**METROPOLITAN DEVELOPMENT COMMISSION
HEARING EXAMINER**

Case Number: 2026-CZN-827 / 2026-CPL-827

Request: Approval of a Subdivision Plat to be known as Wagner Lane Estates, Section 2, subdividing 2.27 acres into nine lots.

Staff Recommendation: Staff recommends **approval** of the rezoning.
Staff recommends **approval** of the plat, subject to conditions.

2026-CZN-827 / 2026-CPL-827; Preliminary Plat

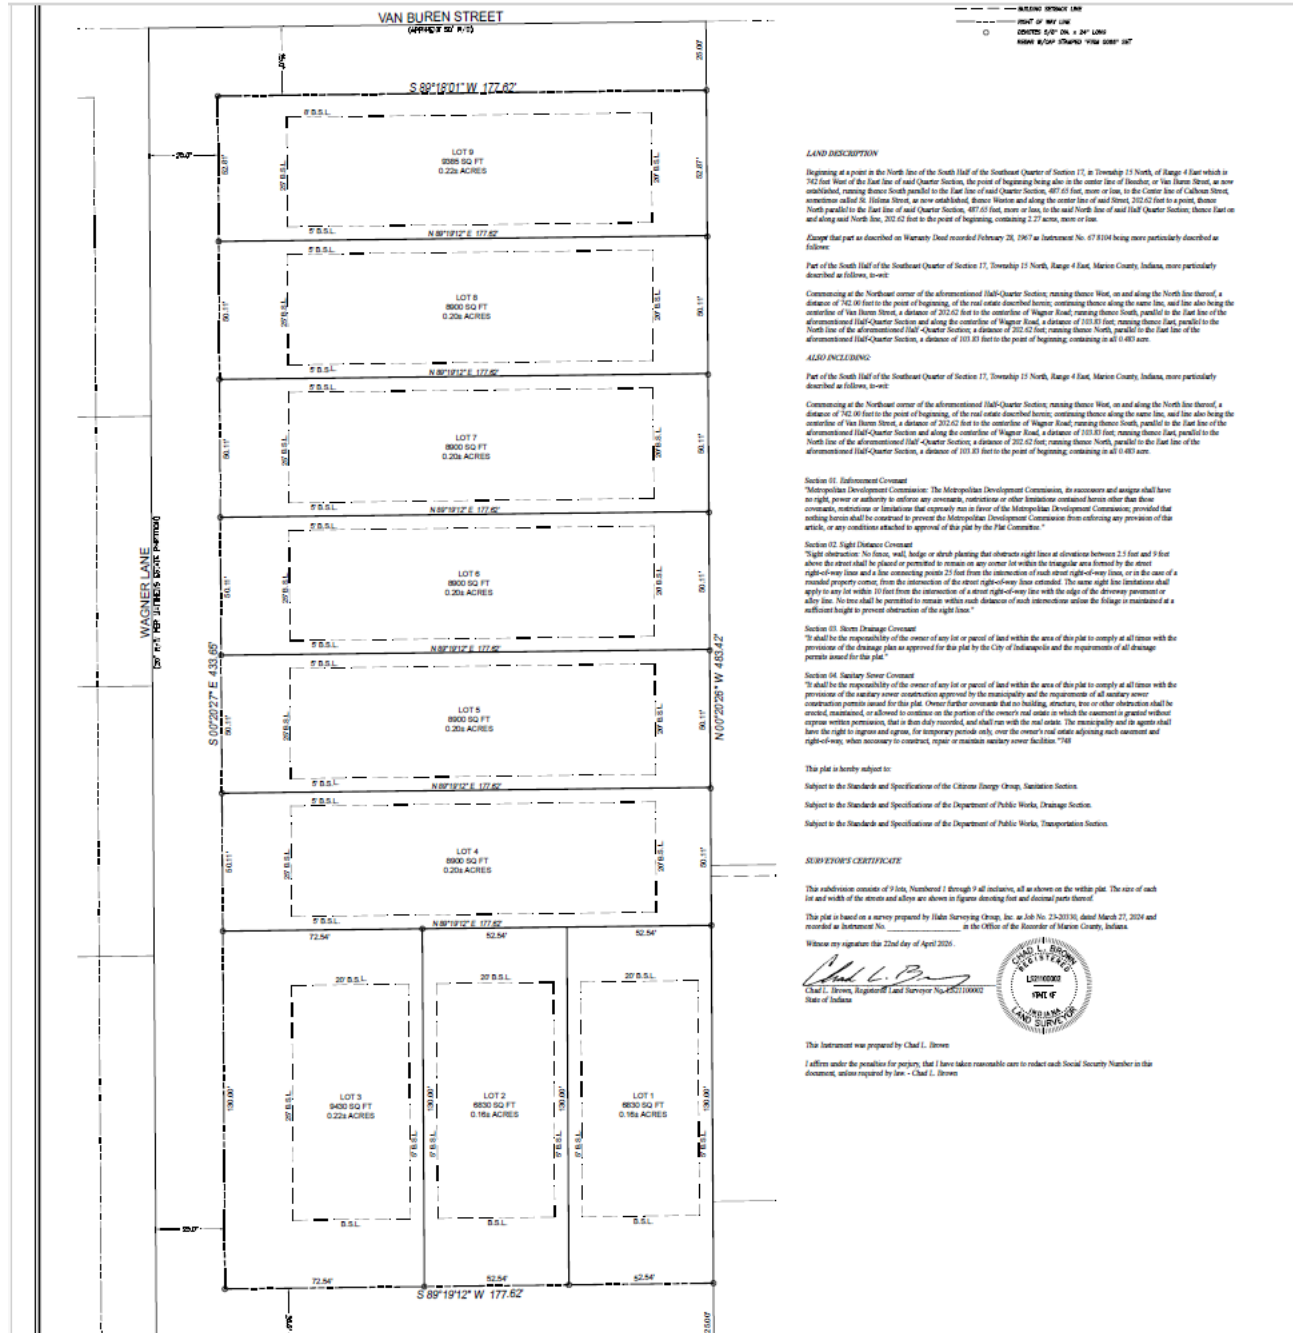
Approval of the plat petition would result in the creation of nine separate lots. Lots 1-3 would front on Calhoun Street. Lots 1 and 2 would be approximately 0.16-acre while Lot 3, on the corner of Wagner and Calhoun, would be approximately 0.22-acre. Lots 4-9 would front Wagner Street. Lots 4-8 would have a size of approximately 0.20-acre while Lot 9, at the corner of Wagner and Van Buren, would be 0.22-acre.

No new streets would be created as a part of the plat. Sidewalks are required per 741-306. No sidewalk waiver has been requested, and site plans appear to show the installation of sidewalks. The proposed lots would meet standards of the D-5 zoning district.

Staff recommends that the Hearing Examiner **approve** and find that the plat, file-dated April 22, 2026, complies with the standards of the Subdivision regulations, subject to the following conditions:
